ADDENDUM #2
CITY HALL REMODEL
BID # 20/21-008 / PWP # WA-2021-135
BIDS DUE NO LATER THAN: 1:45 PM ON FEBRUARY 17, 2021 - REVISED
PUBLIC BID OPENING: 2:00 PM ON FEBRUARY 17, 2021 - REVISED

This addendum is to notify all potential proposers of clarifications made to the Bid documents as stated below.

RFI Questions and Answers:

RESTROOMS - PLANS, SECTIONS, ELEVATIONS

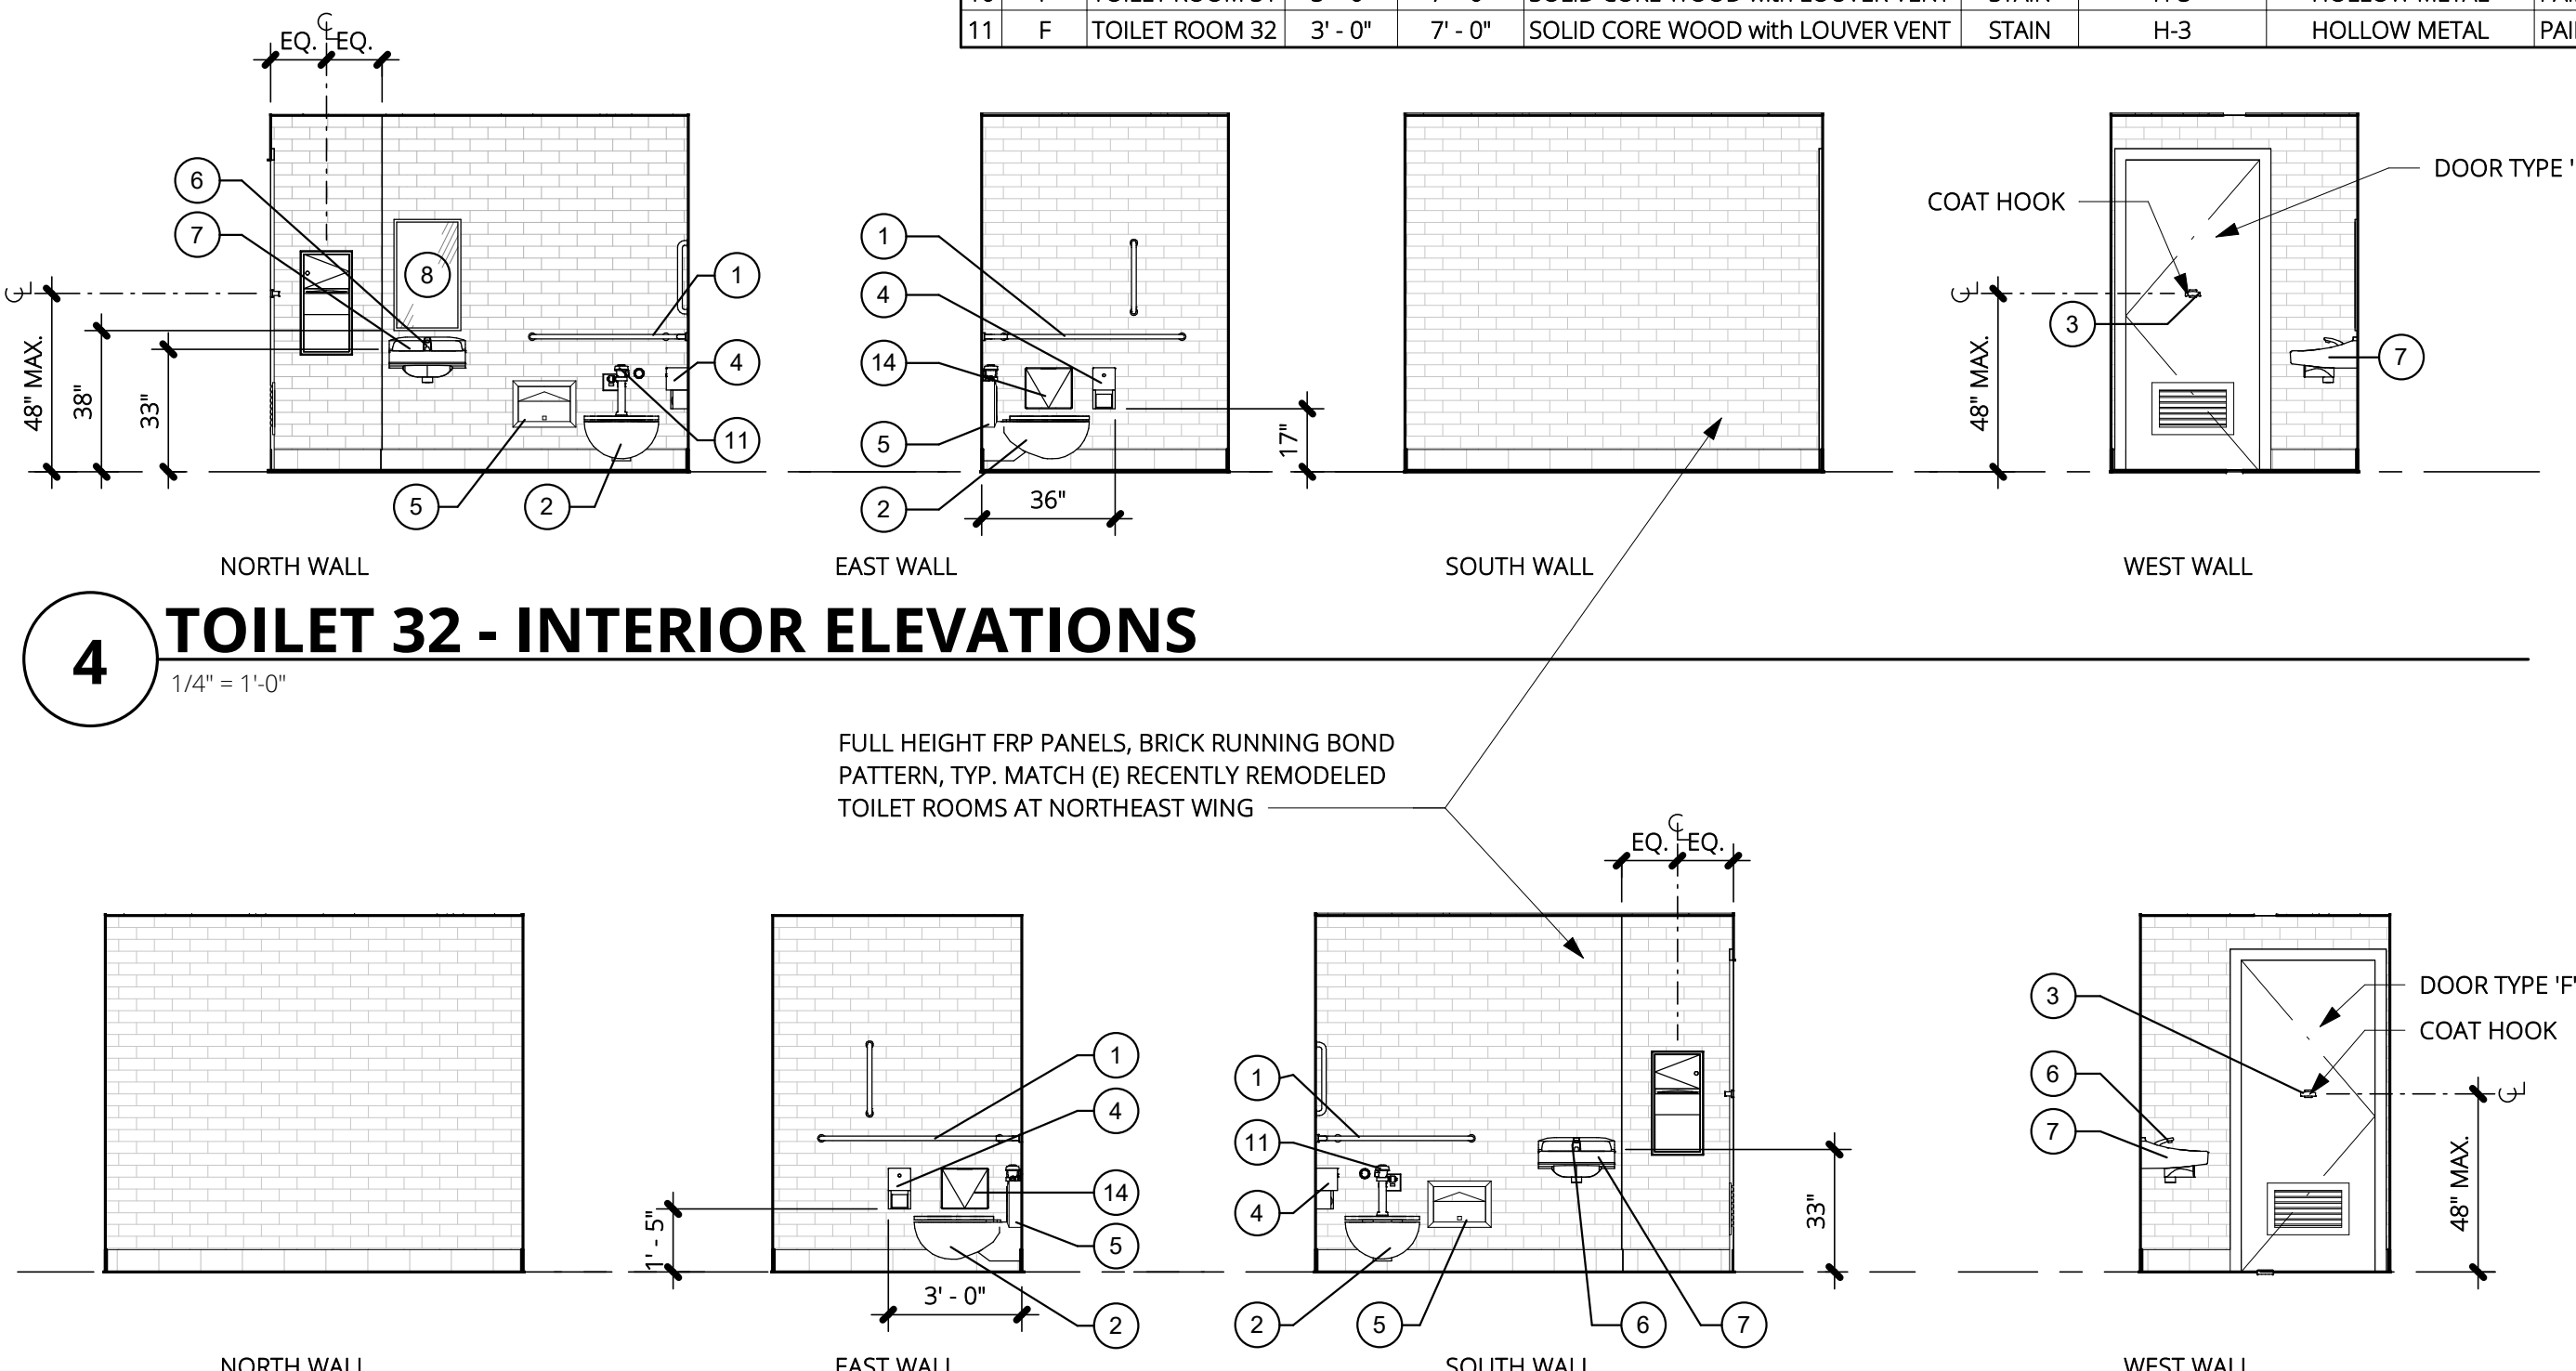
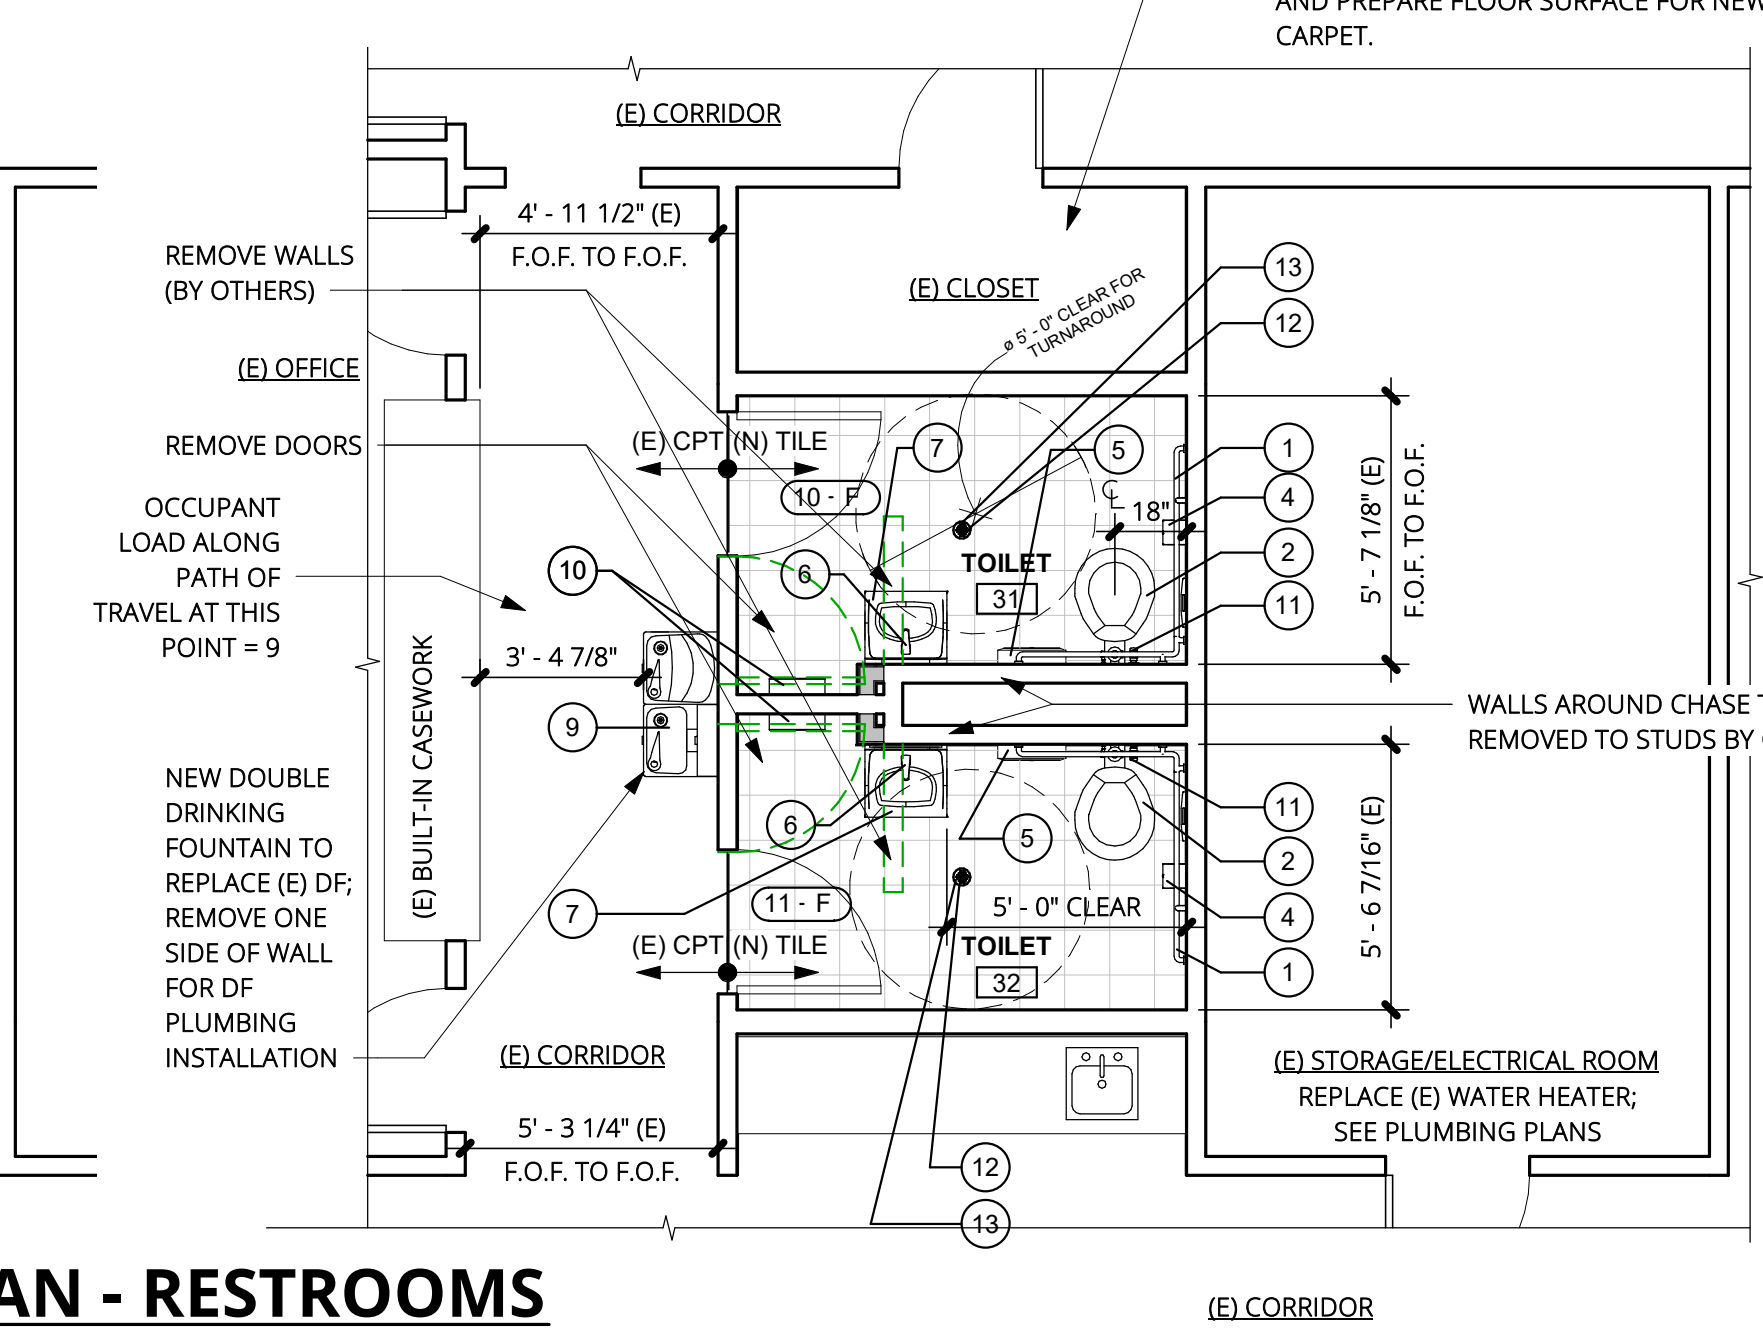
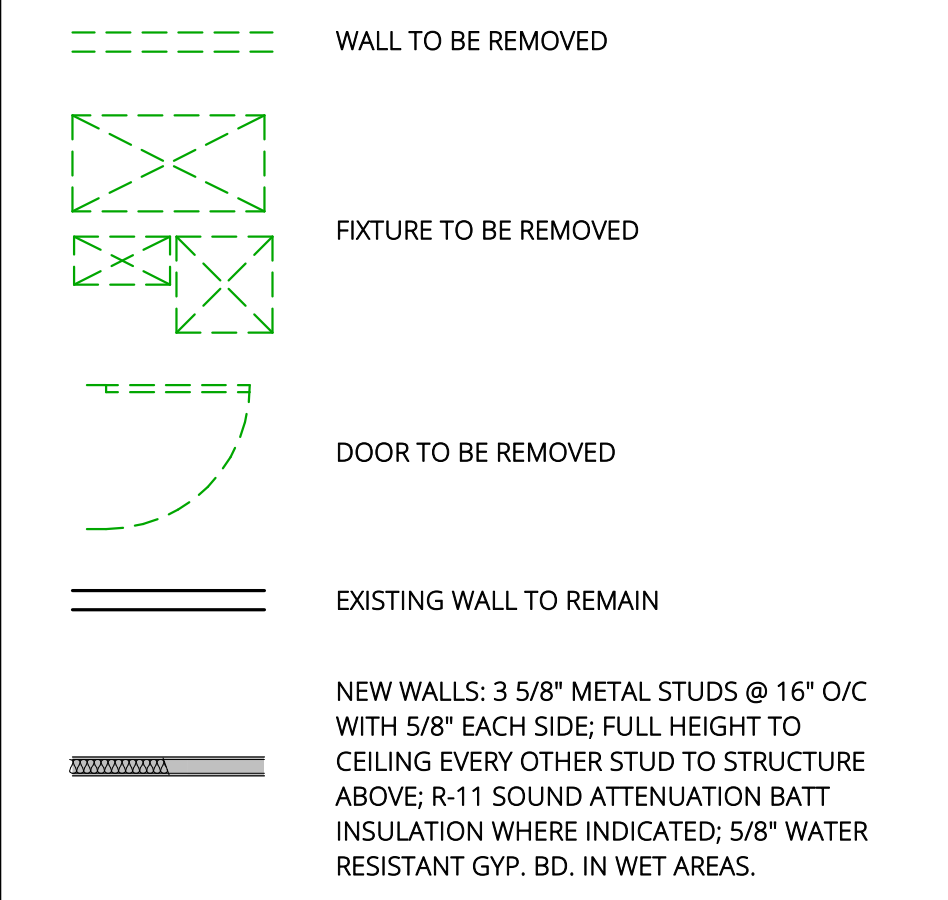
- e) Sheet a203, toilet interior elevations show a vertical grab bar. This vertical grab bar is not listed in the Restroom Equipment & Accessories Schedule. Will this vertical grab bar be required?

- j) Is the removal of the existing floor drain, sink, and water lines in closet by others on sheet A203?
 - i) **Answer:** The existing floor drain, sink, and water lines shall be removed by others as shown on the attached revised plan sheet A203. The contractor bidding on this project shall be responsible for patching/painting the walls in this closet along with installing new carpet and moving the existing floor drain to the adjacent storage/mechanical/electrical room to accommodate the new hot water heater as shown on sheet P101 and P201.

- k) How should we handle the wallpaper that is outside of the restrooms on sheet A203 where the existing water fountain is removed, and the new water fountains will be installed?
 - i) **Answer:** The wallpaper shall be removed from corner to corner, repaired with a flat finish, and painted to match the existing paint (paint color provided by City).

- i) **Answer:** Yes, a vertical 18" grab bar is required per ADA and will be required in each new restroom.
- f) Please confirm the following:
Bid Item #1 – To include all work shown on 1/a202
Bid Item #2 – To include all work shown on 1/a205
Bid Item #3 – To include all work shown on 1/a201, identified as New Mail Room
Bid Item #4 – To include all work shown on 1/a201, identified as New Enlarged Finance Office
Bid Item #5 – To include all work shown on 1/a203
Bid Item #6 – To include all work shown on 1/a204
